UNITED STATES PATENT AND TRADEMARK OFFICE

APPLICATION NO.	FILING DATE	FIRST NAMED INVENTOR	ATTORNEY DOCKET NO.	CONFIRMATION NO.
10/775,522	02/10/2004	Matthew G. Goodman	ASMEX.433A	1057

Office Action Summary

DETAILED ACTION

Kikuchi (US 5,226,056), Fig. 16

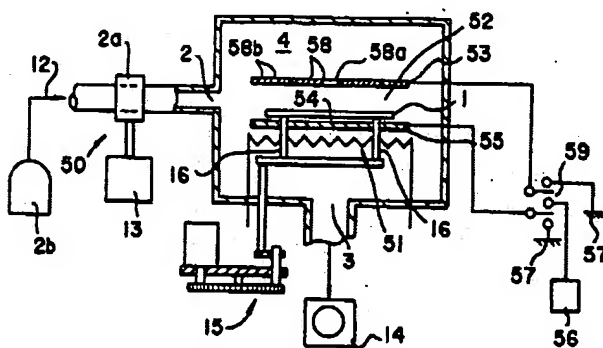
The first load platform 16 is mounted on element 15 which is located outside of the second platform, see Fig.16. See also Figs. 11 and 15 which illustrate the first platform mounted outside of the second platform.

5. Applicant's arguments filed 1/18/2006 have been fully considered but they are not persuasive. Applicant argues the first load platform of Kikuchi is not outside the second load platform but the examiner disagrees.

Fig. 16 of Kikuchi (altered by the examiner)

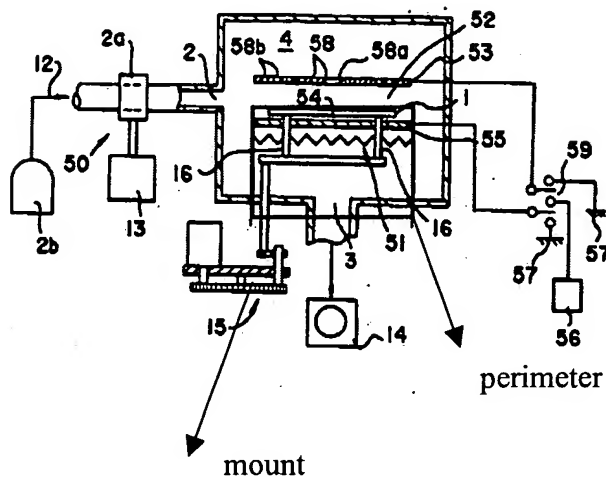
Applicant's further argues that the first platform is not mounted outside *of the perimeter of the* second load platform. The examiner first notes that applicant has not amended the claim to reflect this clarification. Nevertheless, the examiner defines perimeter as outer limits or boundaries of. In this case the examiner's interpretation of the perimeter of the second load platform is illustrated with a box, seen in the altered figure of Kikuchi below.
